Entergy

OCAN070302

Subject: Arkansas Nuclear One - Units 1 and 2
Docket Nos. 50-313 and 50-368
License Nos. DPR-51 and NPF-6
NRC Triennial Fire Protection Inspection Report 01-06; EA-03-016
Significance Determination Process Report

Figure 10: Selected heat release rate profile for cabinet fires in switchgear room 99M.

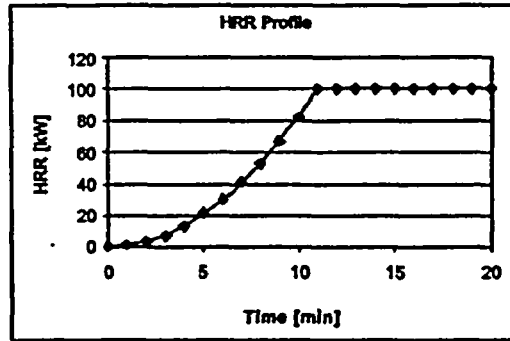
One 4KV?
100kW peak in 12min
Burns for 8min

is NUREG
4527 correct?

is the EPRI model correct?

Figure 14: CFAST results for upper layer and heat release rate in scenario 1a.

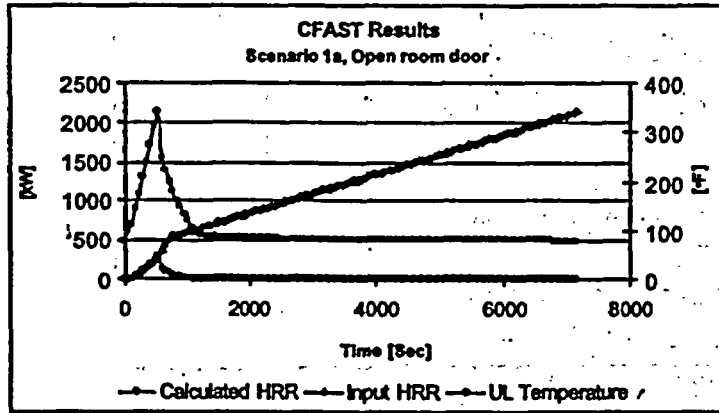
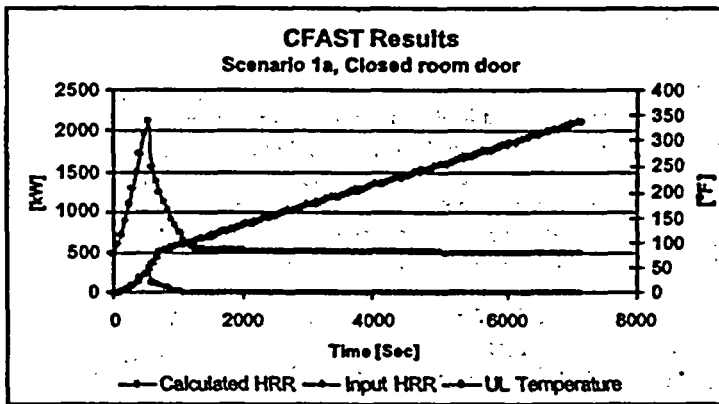
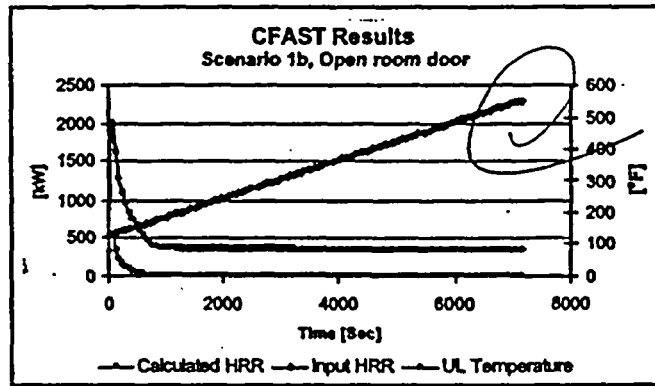
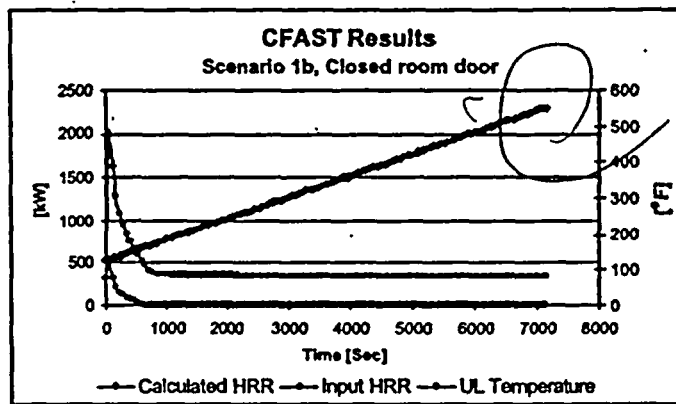
?? N/A stated
Other models would
reach > 700 °F. what
is going on?

Does this mean the fire puts itself out before the fire bridge shows up?
